HISTORIC AND DESIGN REVIEW COMMISSION

HDRC CASE NO: 2018-208
ADDRESS: 802 NOLAN
LEGAL DESCRIPTION: NCB 563 BLK 7 LOT W102.6 FT OF 1 AT 802 NOLAN
ZONING: R-6, H
CITY COUNCIL DIST.: 2
DISTRICT: Dignowity Hill Historic District
APPLICANT: Jenny Hernandez
OWNER: Mike O'Neal
TYPE OF WORK: Construction of a single family, residential structure
APPLICATION RECEIVED: October 16, 2018
60-DAY REVIEW: December 15, 2018

REQUEST:

The applicant is requesting a Certificate of Appropriateness for approval to construct a single family, residential structure on the vacant lot at 802 Nolan Street, in the Dignowity Hill Historic District. The proposed new construction is to feature one story in height and a detached garage.

LEFT ELEVATION

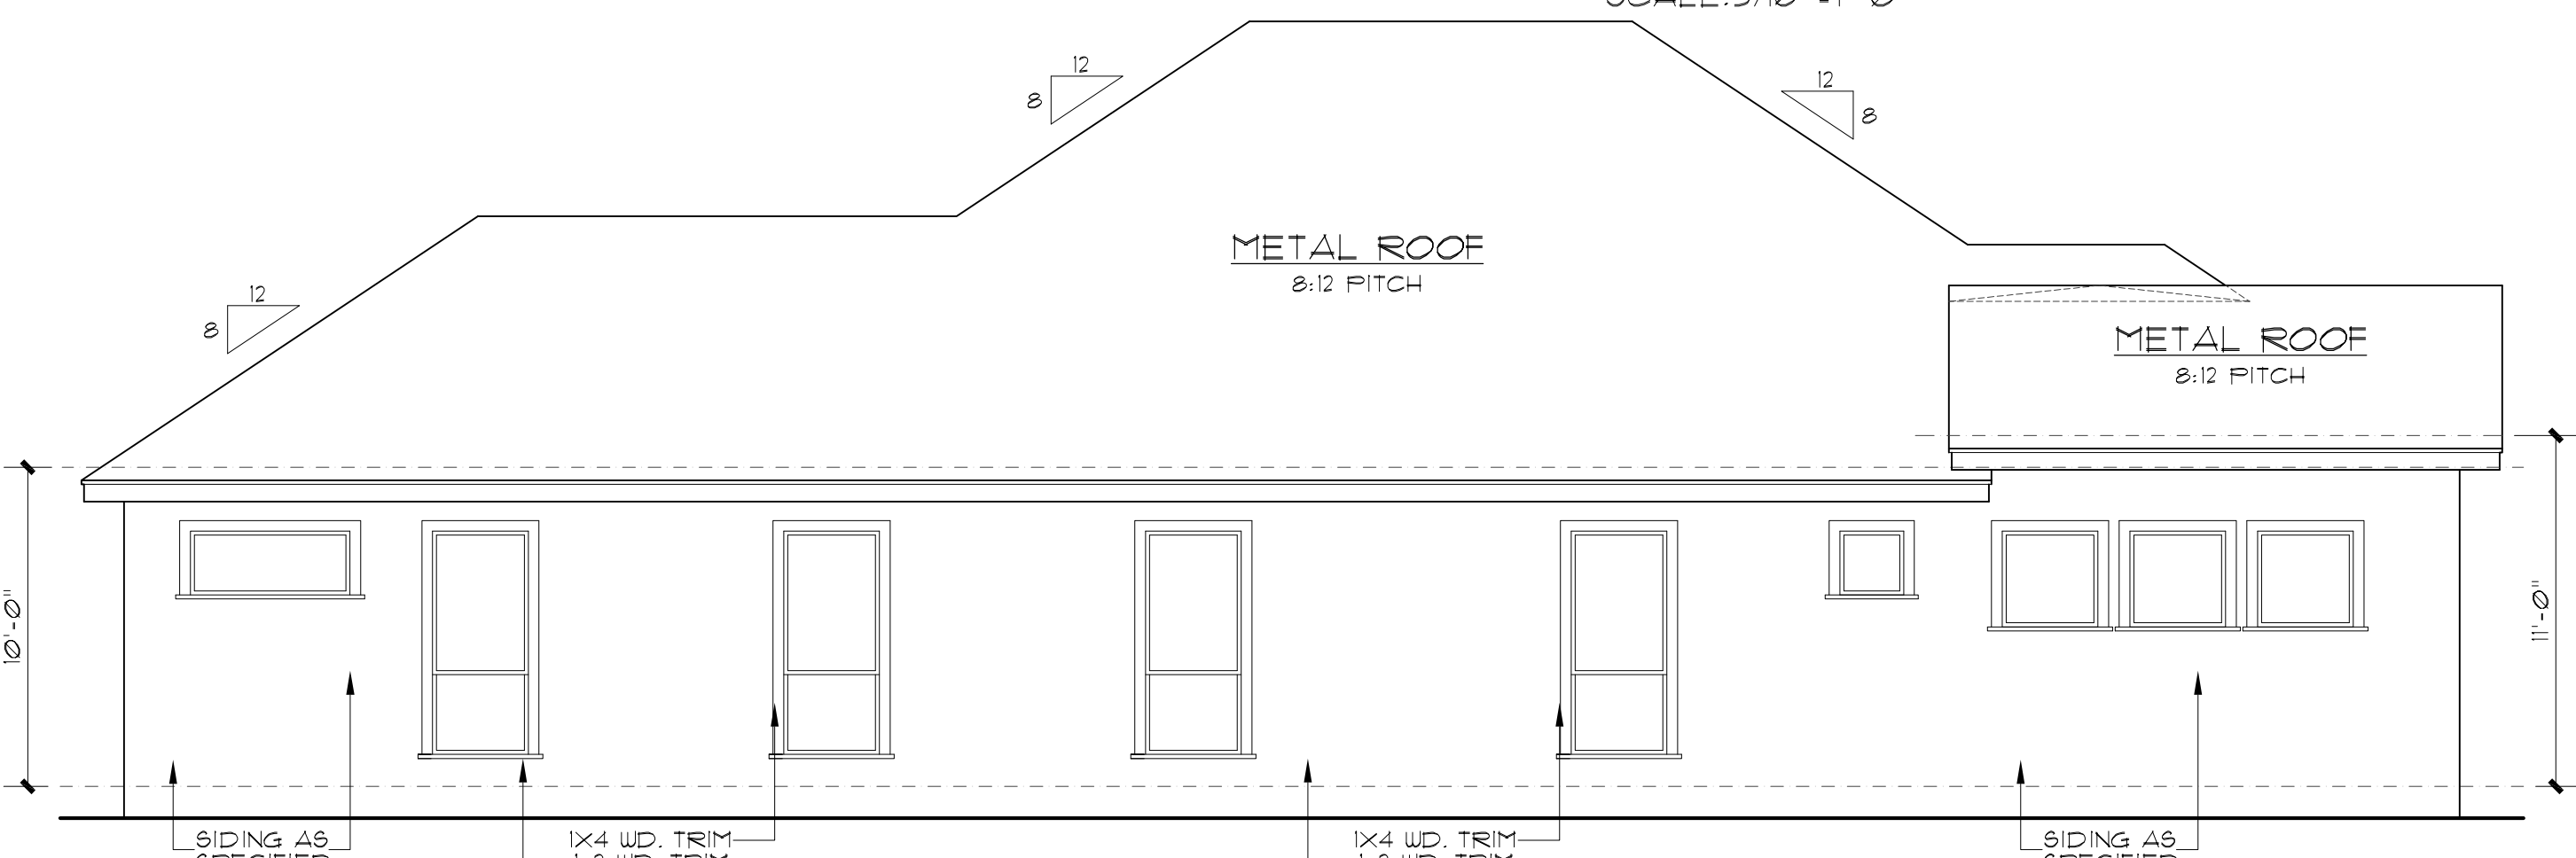
- g. WINDOW & DOOR OPENINGS – Per the Guidelines for New Construction 2.C.i., window and door openings with similar proportions of wall to window space as typical with nearby historic facades should be incorporated into new construction. Generally, the applicant has proposed window and door openings that are consistent with the Guidelines in regards to locations and profiles. The applicant has also added fenestration into the bedrooms as previously stipulated. Staff finds that windows should be incorporated into the west façade (kitchen space).

- ii. That the applicant ensure that a foundation height of at least one (1) foot is used as noted in finding e.
- iii. That the applicant add additional fenestration to locations currently featuring blank walls, specifically the kitchen on the west elevation beneath the wraparound porch.

GARAGE FRONT ELEVATION
SCALE: 1/4" = 1'-0"

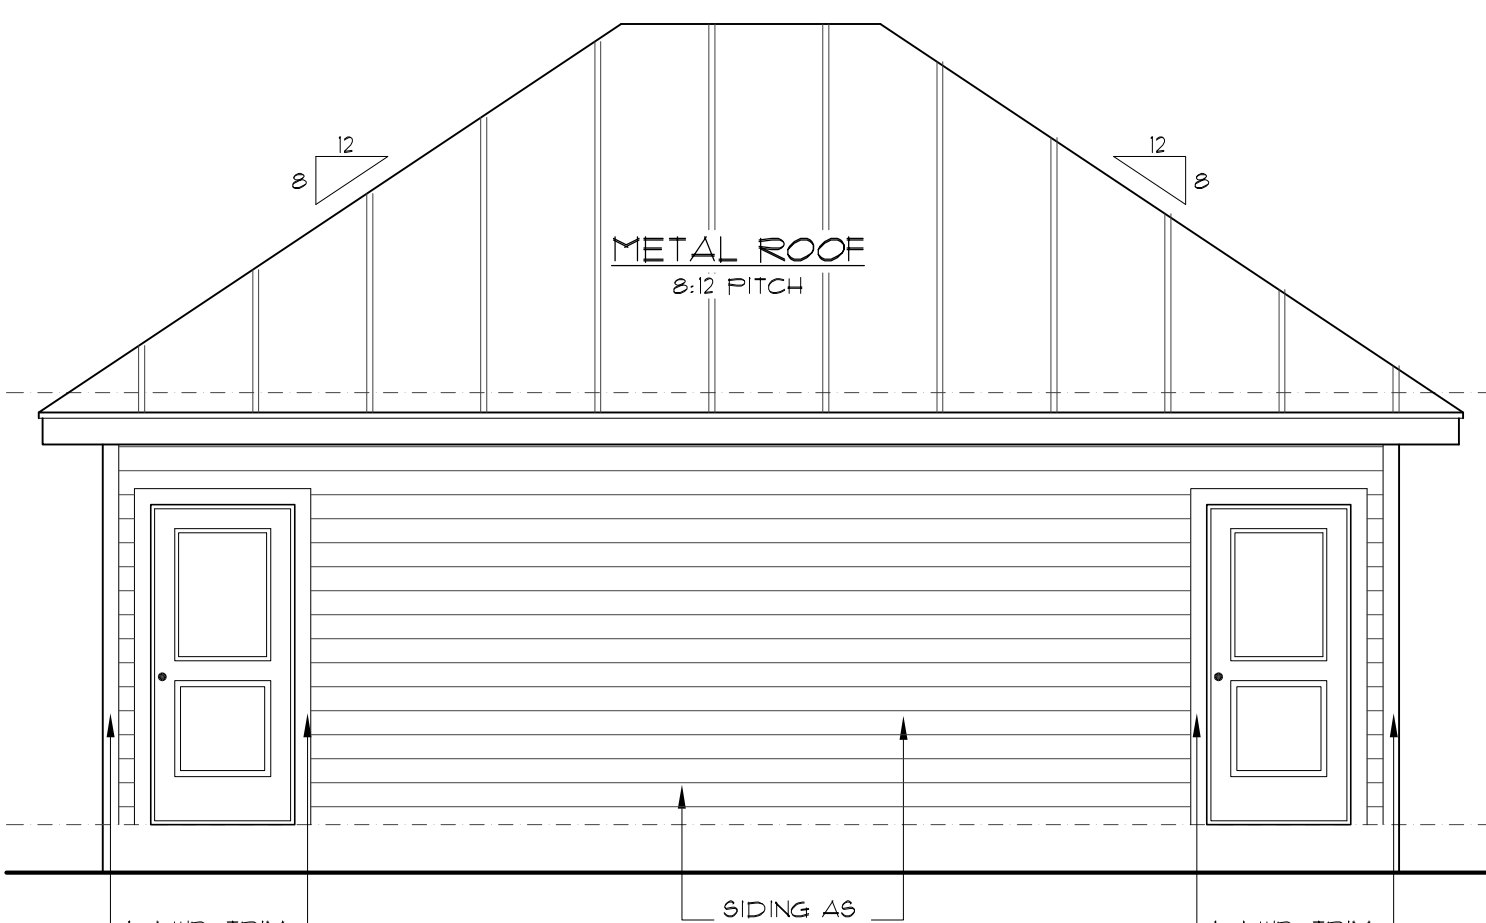
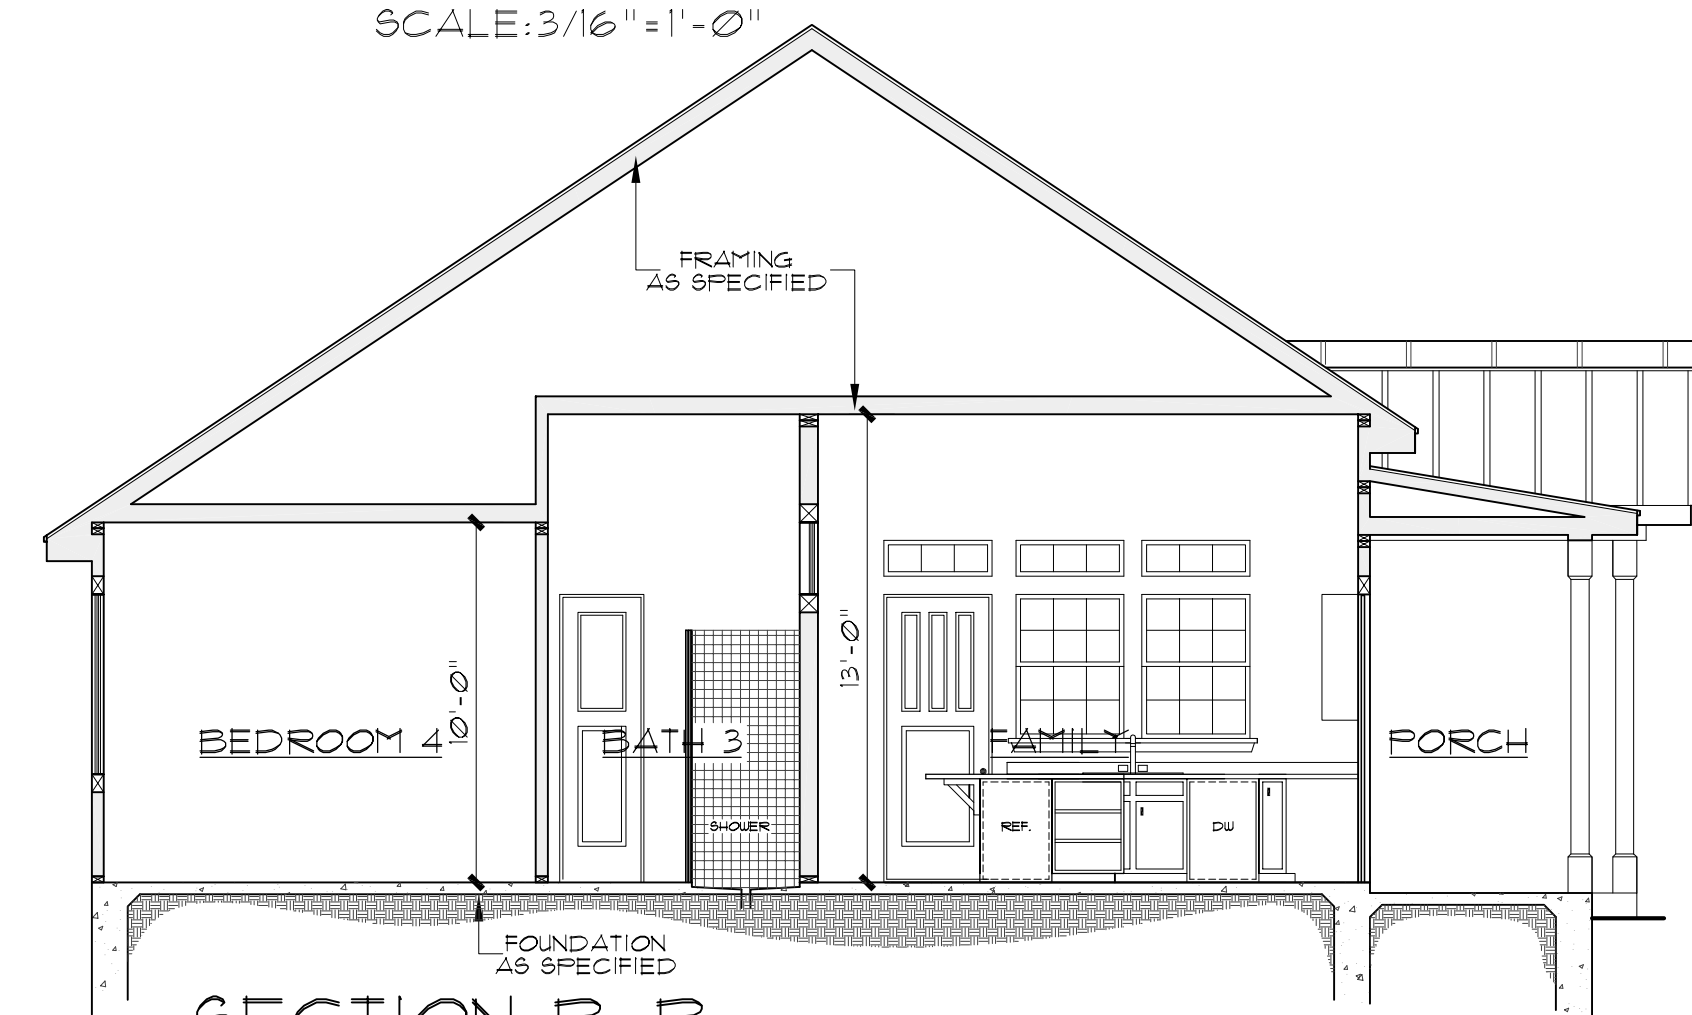
- viii. That the rear garage feature metal or wood doors.
- c. SETBACKS & ORIENTATION – According to the Guidelines for New Construction, the front facades of new buildings are to align with front facades of adjacent buildings where a consistent setback has been established along the street frontage. Additionally, the orientation of new construction should be consistent with the historic examples found on the block. The applicant has noted a setback of twenty (20) feet from the front property line; however, the applicant has not specified the setback from the street. The applicant should ensure that a setback that is greater than those found historically on the block are used for Nolan Street. The applicant should ensure that the proposed garage is behind the front façade wall plane of the neighboring house found on N Olive.

- v. That the rear garage feature metal or wood doors.
